Product Change Notice (PCN)

PCN Number: PCN-0451156R-01

Product(s) Affected: PJ-039A, PJ-039B, PJ-039AH, PJ-039BH

Current version	New version
Outlook		
Front	<p>without chamfer</p> 	<p>with chamfer</p>

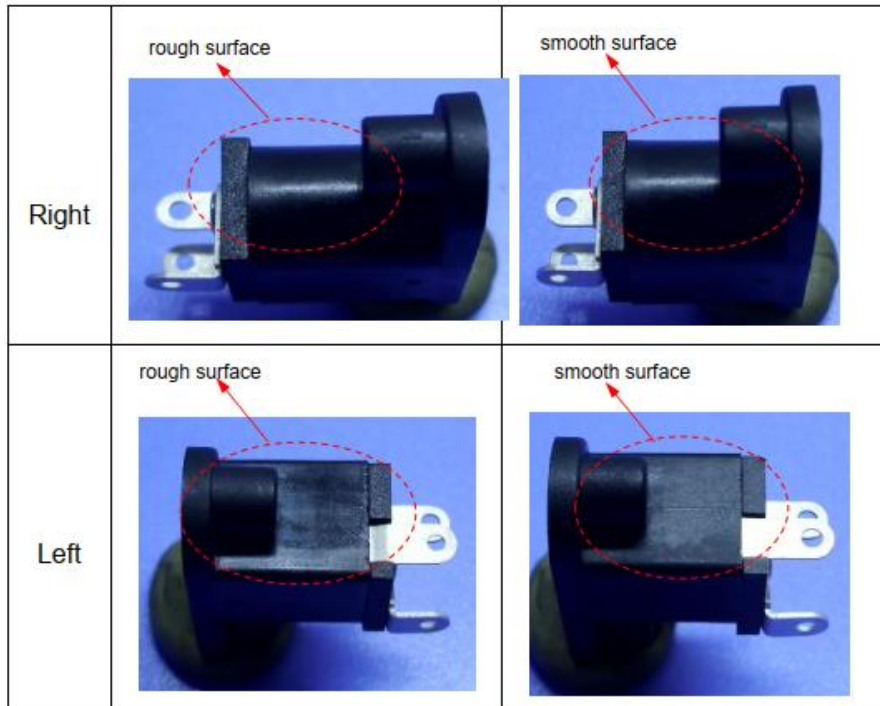
Description of Change: Thickness of pin 2 changed from 0.2mm to 0.25mm. Aesthetic changes as shown in below comparisons:

<p>Back</p>	<p>cave marking location</p>  <p>smaller</p> <p>cave marking location</p>	<p>cave marking location</p>  <p>thicker</p> <p>cave marking location</p>
<p>Top</p>	<p>with injection mark</p>  <p>thickness of pin#2 is 0.2mm</p>	<p>without injection mark</p>  <p>thickness of pin#2 is 0.25mm</p>
<p>Bottom</p>	<p>without injection mark</p> 	<p>with injection mark</p>
